**NEW MEXICO  
ENVIRONMENT DEPARTMENT**

*Hazardous Waste Bureau*

**RE: REPLACEMENT PAGES, QUARTERLY PRE-REMEDY MONITORING AND  
SITE INVESTIGATION REPORT FOR JANUARY-MARCH 2011, BULK  
FUELS FACILITY SPILL, SOLID WASTE MANAGEMENT UNITS ST-106 AND  
SS-111, MAY 2011  
KIRTLAND AIR FORCE BASE, EPA ID# NM9570024423  
HWB-KAFB-11-008**

**Figure 1.** From Replacement Pages, Figure 5-4, Groundwater Level Contours March 2011. Note water-level elevations of 4857.11 ft for KABB-10614 and 4856.00 ft for KAFB-10619. Compare these water-level elevations with those shown in Figure 2 and listed in Table 1.

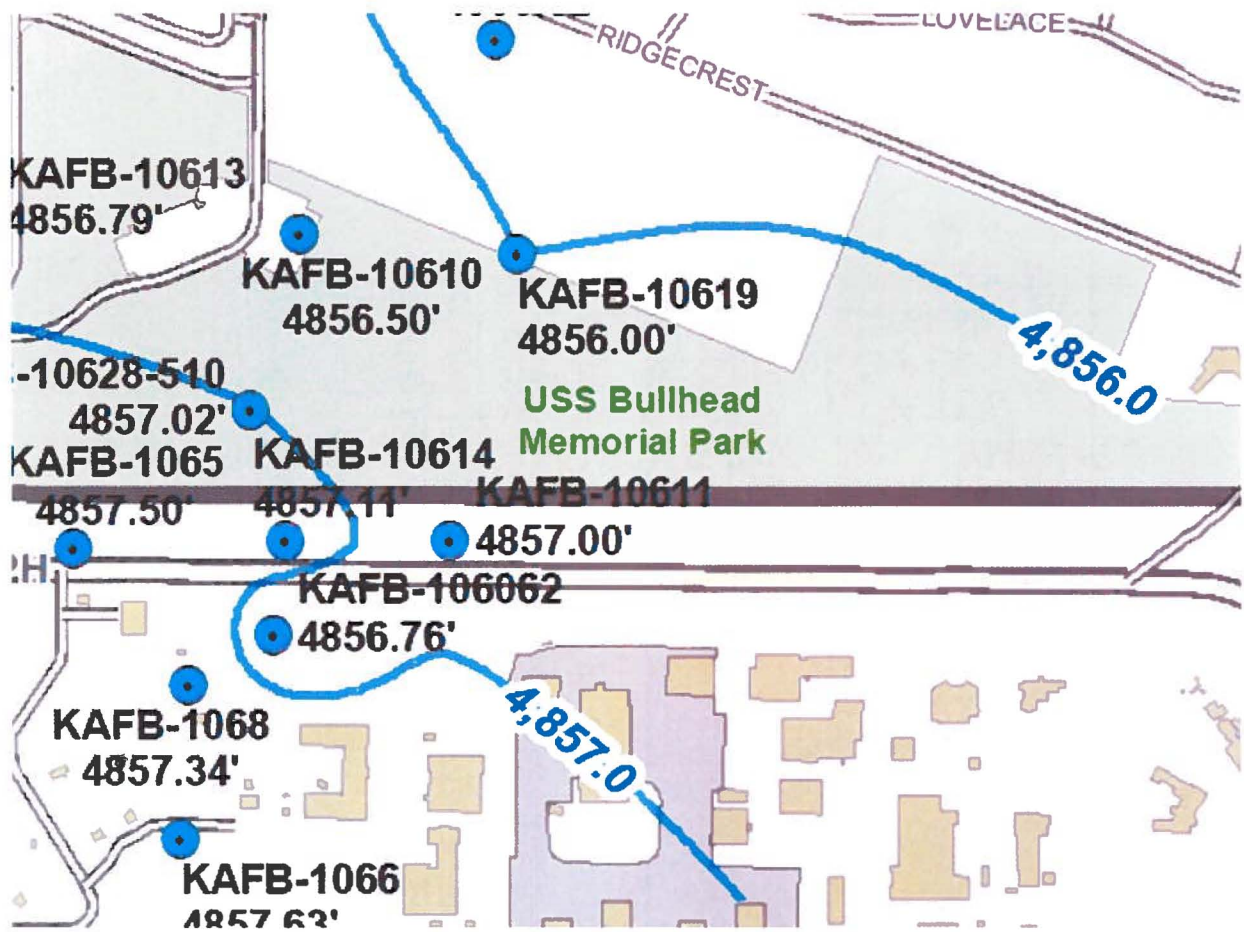
1. The U. S. Air Force (Permittee) submitted revisions of Figures 5-2 through 5-4 (Groundwater Level Contours) as part of the Replacement Pages without providing an explanation for the revisions. Table 5-2 (Historical Groundwater Level and Liquid Measurement Data) appears to be the same in both the original report and the Replacement Pages (other than a pagination change). However, not all data posted on the figures match their corresponding data in the table. For example, in March 2011 the water-level elevation for monitoring well KAFB-10614 is shown as 4857.11 ft in Replacement Pages Figure 5-4, as 4856.91 ft in Figure 5-4 of the original report, and is listed as 4856.62 ft in Table 5-2 (the cited figures and table are reproduced here in part as

Figures 1 and 2 and Table 1 of this letter). In fact, there are numerous other examples of such inconsistencies between the figures and the table, indicating that the water-level map shown in Figure 5-4 (of the original report and the Replacement Pages) and/or the data in Table 5-2 may be replete with errors, and thus, are unreliable. The Permittee must correct the figures or the table, or both, as necessary and resubmit the corrected information to the NMED. Also, Figures 5-2 and 5-3 must also be corrected, as they have problems similar to those described above for Figure 5-4. Furthermore, any changes in the figures or table would probably necessitate changes to Figure 5-5 (Groundwater Gradient March 2011), also resubmitted in the Replacement Pages. If so, Figure 5.5 must also be corrected and must also be submitted to the NMED.

3. NMED notes a water-level contour constructed with a bend at nearly a right angle, specifically the 4856.0-ft contour near KAFB-10619 on Figure 5-4 of the Replacement Pages (reproduced here in part as Figure 1 of this letter). Typically, such sharp angles would not be expected as a component of the contours that model the water table of an unconfined aquifer in an unconsolidated basin-fill environment. NMED also notes the odd, contorted 4857.0-ft contour that nearly completely surrounds KAFB-106062 (see Figure 1 of this letter) and questions whether this odd geometry is related to survey error or other error. The Permittee must justify such unusual components of the model of the water table, or revise the model to be consistent with that expected for natural conditions.

Also note water-level contour constructed at nearly a right angle, specifically the 4856.0-ft contour placed near KAFB-10619, and odd contorted 4857.0-ft contour line constructed nearly completely around KAFB-106062.

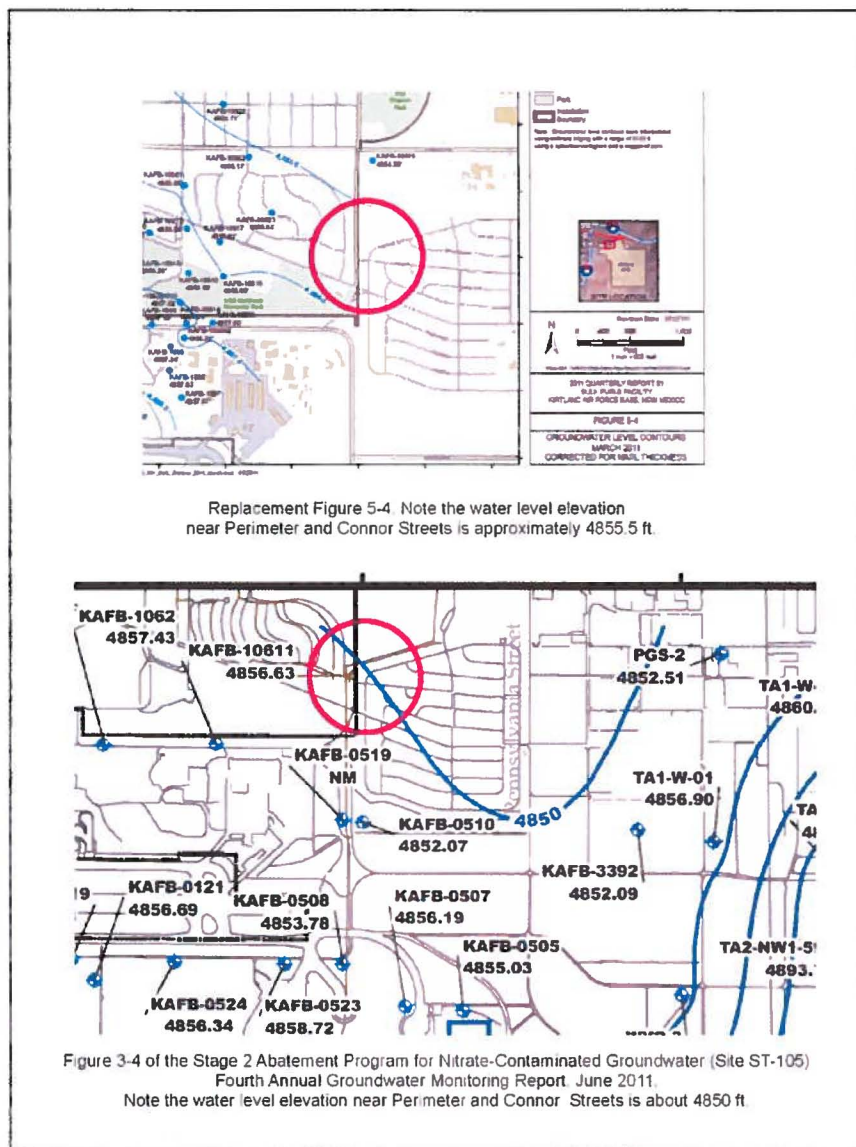
2. As discussed with the Permittees and their contractor at a technical meeting held on July 12, 2011, the Permittees submitted a water-level map in the document *Stage 2 Abatement Program for Nitrate Contaminated Groundwater (Site ST-105) Fourth Annual Groundwater Monitoring Report, June 2011* (this map is reproduced here in part as the lower map in Figure 3 of this letter). On this map, the water-level elevation near the intersection of Perimeter and Connor Streets is about 5 ft lower compared with that shown on Figures 5-2 through 5-4 of the Replacement Pages (and the same figures in the original report) for a similar time period. Taking into consideration the water-level elevation for KAFB-0510 (as presented in the nitrate report), the geometry of the water table on the east side of Bulk Fuels Facility could be considerably different from that presented in the Replacement Pages and other reports for the Bulk Fuels Facility Spill, and, as a consequence, the groundwater flow direction and gradient for this area could be markedly different from that previously determined. The Permittee must correct the figures for the Bulk Fuels Facility Spill quarterly report as necessary and submit the corrected figures to the NMED. The Permittee must also correct any figures that are erroneous in the aforementioned nitrate report and must submit the corrected figures to the NMED Ground Water Quality Bureau, with a copy to the NMED Hazardous Waste Bureau.

Figure 4. Comparison of Colog and Jet West Long Normal (deep) Induction Log at KAFB-106

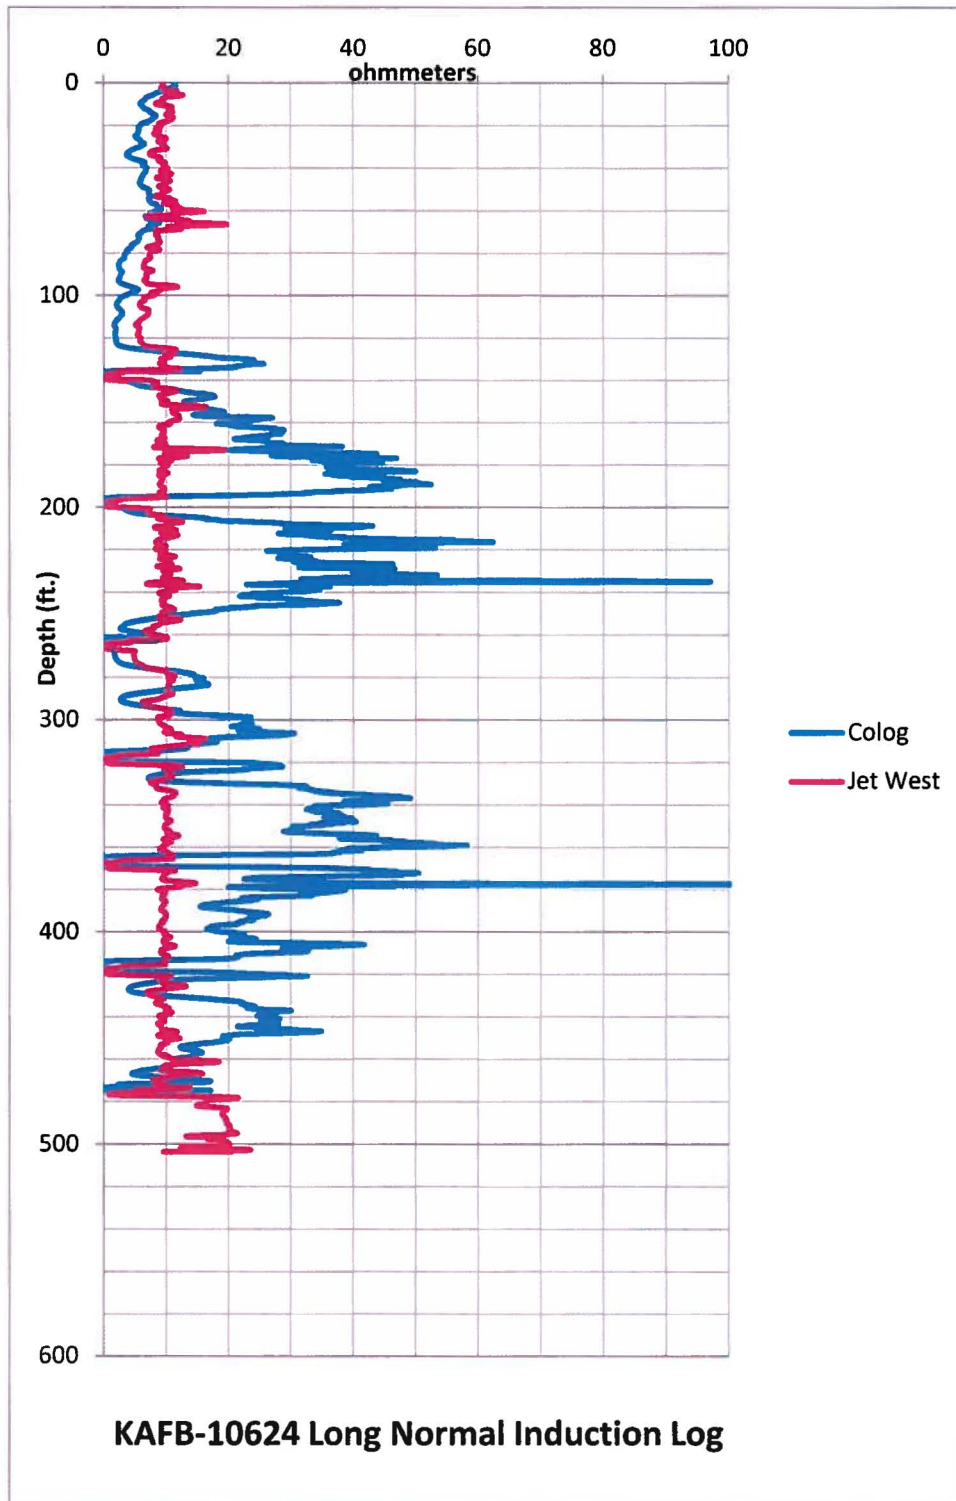
**Example 1:** The geology of one well, KAFB-10624 was logged by both Colog and Jet West; the long normal (deep) induction logs for KAFB-10624 are shown in Figure 4 of this letter. For about half of the well logs, the resistivity values in the Colog data are about 2 to 4 times higher in magnitude compared to the Jet West data. In other areas of the well logs, the Colog resistivity values are less than the Jet West resistivity values. Because the well environment did not change, these data show that at least one set, and possibly both sets, of the logging instruments that generated the logs were not properly calibrated to a known standard (ohmmeters).

**Figure 5.** Comparison of Gamma logs generated by Colog and Jet West at KAFB-10624. In each case the gamma tool was run with another tool, either the neutron or the induction tool, as noted in the legend.

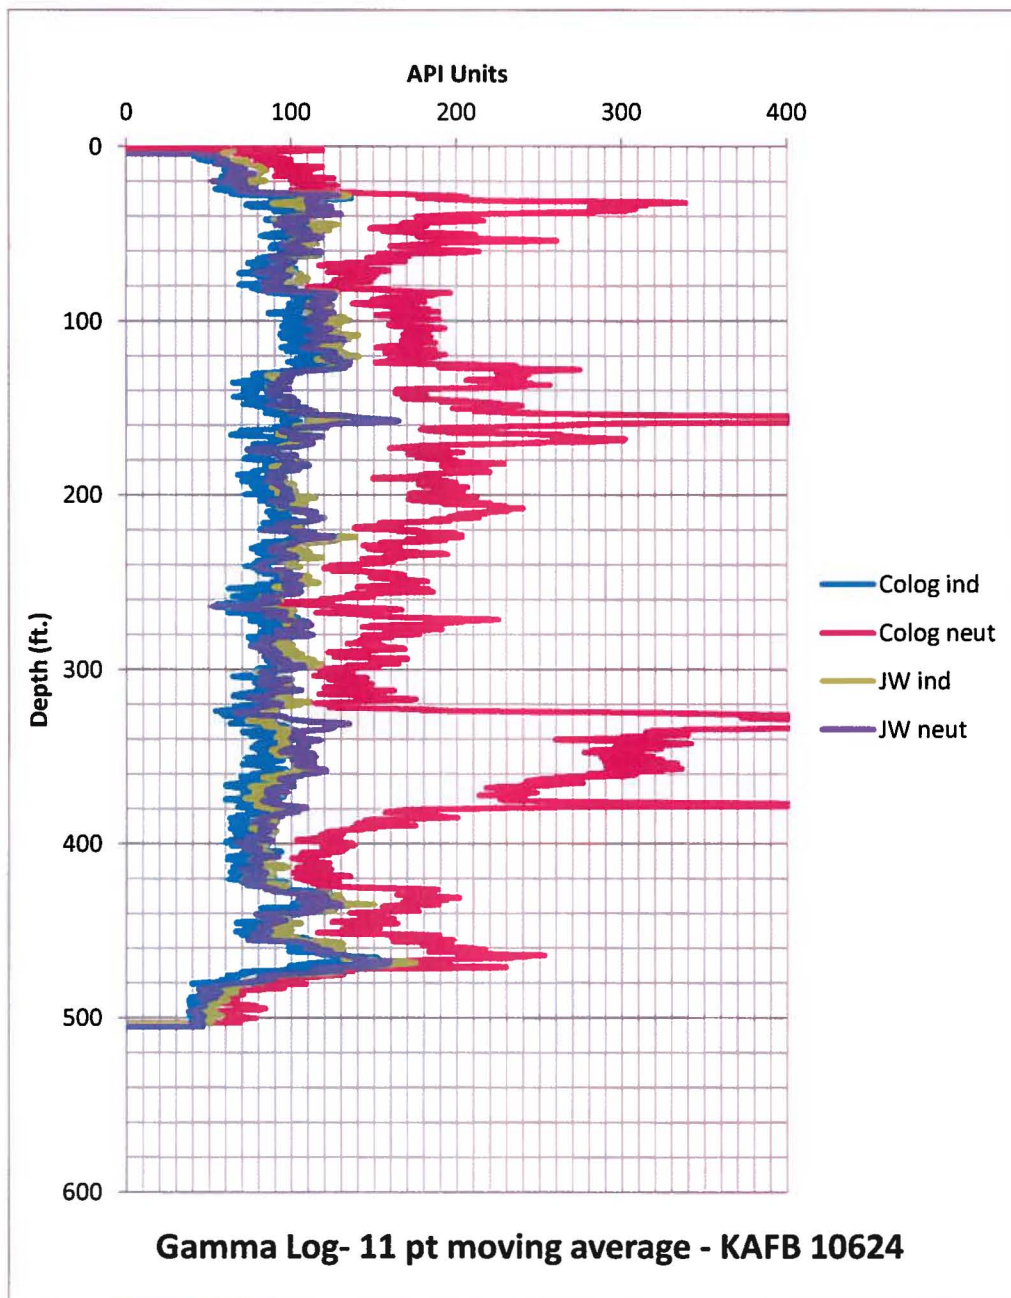
**Example 2:** Both logging contractors produced two gamma logs each for KAFB-10624; one each associated with the induction tool and one each associated with the neutron tool (see Figure 5). While 3 of the 4 logs match up reasonably well, the gamma log generated by Colog on the neutron tool is considerably different in magnitude (API units) than the other three logs suggesting that one or more of the logging tools was not properly calibrated.

**Figure 6.** Comparison of Long Normal (deep) Induction Log between three wells in one cluster, with one of the wells logged by Colog (10627) and the other two wells logged by Jet West (106044 and 106045).

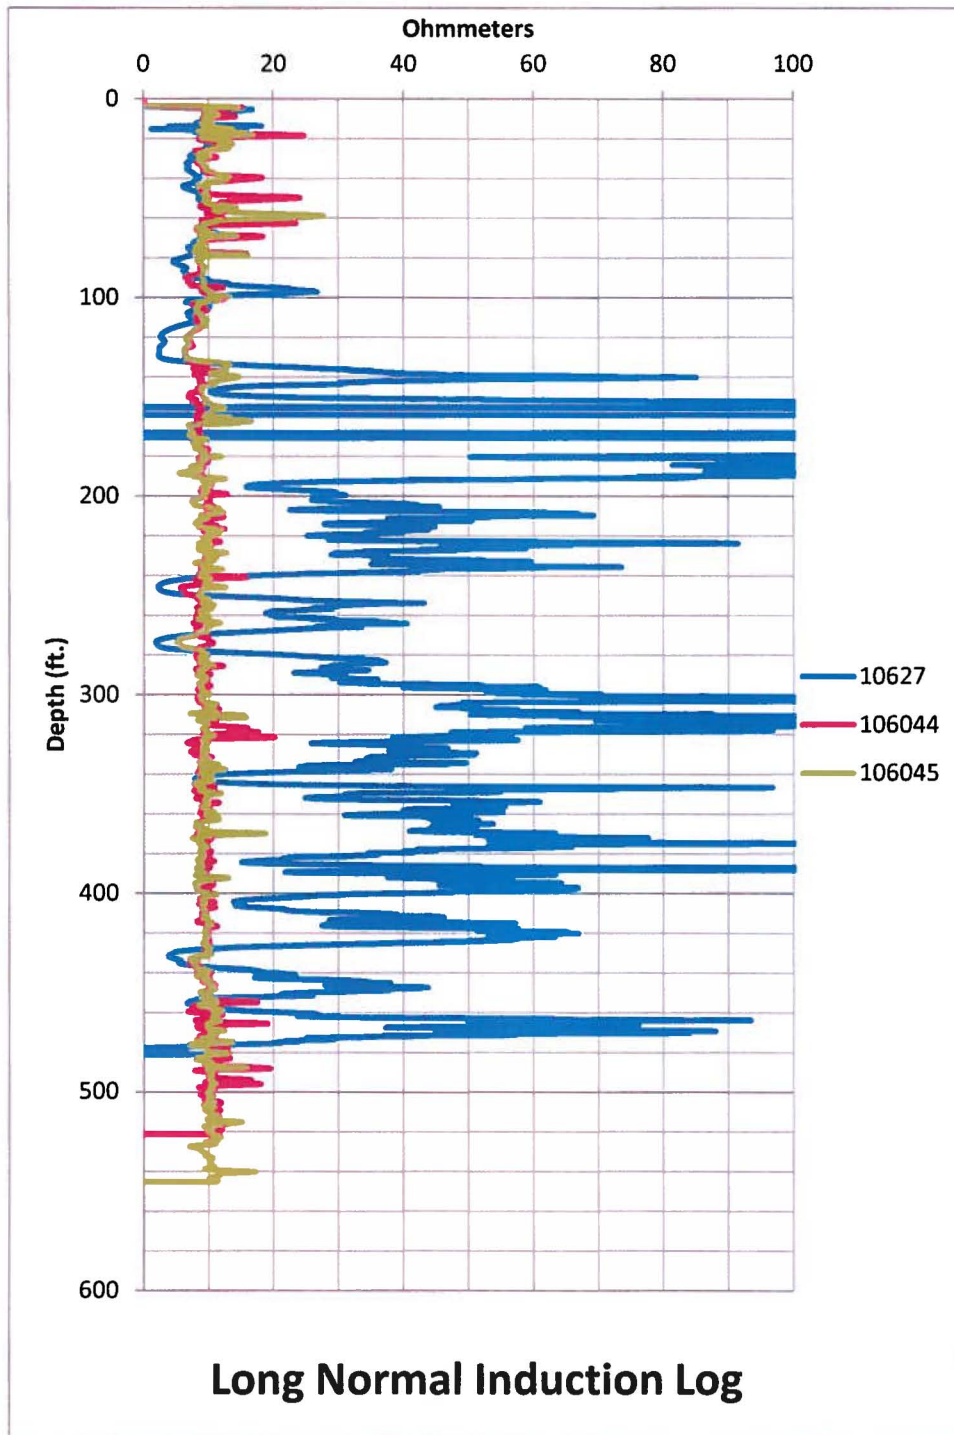
**Example 3:** Figure 6 (and Figure 5) illustrates the importance of having calibrated logs to evaluate the lateral characteristics of a given lithologic unit. Figure 6 shows the logs for the well cluster including wells KAFB-10627, KAFB-106044, and KAFB-106045. The log for well KAFB-10627 produced by Colog exhibits very different resistivity values compared to the logs for KAFB-106044 and KAFB-106045 that were generated by Jet West -- even though the wells are only a few tens of feet apart. These discrepancies are not likely caused by changes in lithology, but instead, are caused by a lack of proper calibration of one or more of the logging tools. Furthermore, Figure 6 (and Figure 5) suggest both the Colog and Jet West logs were generated using instruments that were not properly calibrated.

Figure 7. Comparison of neutron logs generated by Colog and Jet West at KAFB-10624.

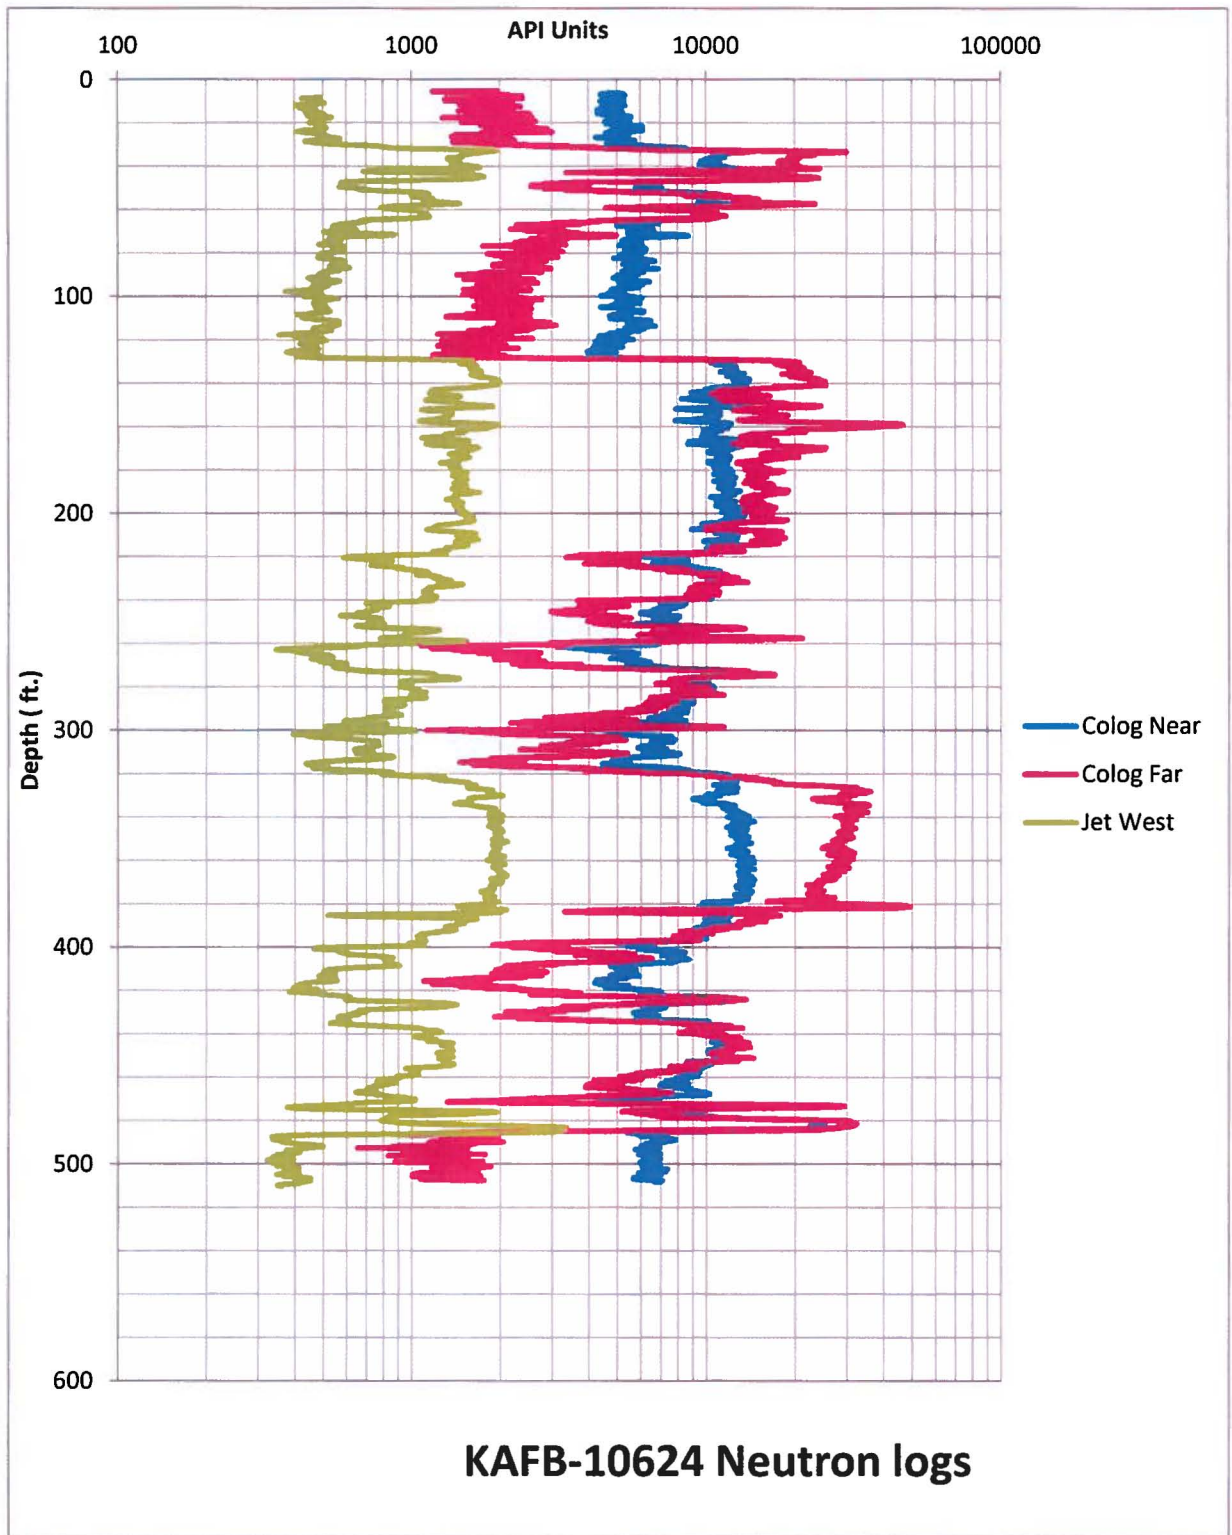
Both contractors generated neutron logs from the logging of well KAFB-10624. Colog produced both near and far neutron logs and Jet West produced a single neutron log for the well. There is a difference of an order of magnitude between the two sets of neutron logs produced by the two contractors (see Figure 7 of this letter).

The NMED also questions the reliability of estimating porosity values from neutron logs exhibiting such markedly different API counts as discussed in Example 4 above. NMED has no confidence in the accuracy of either the Colog or Jet West neutron logs based on the information presented in Figure 7 and the issues related to calibration of the other log types discussed in this letter. For this reason, the Permittee must respond in writing to this comment by stating how it will obtain porosity values from the logs, that it will repeat the neutron logging with properly calibrated tools, or propose another method to measure porosity for the Bulk Fuels Facility Spill project. Porosity data are needed both for saturated conditions throughout the project site and also for the vadose zone in the vicinity of the former fuel offloading rack and perhaps for other source areas that may be present at the Bulk Fuels Facility.
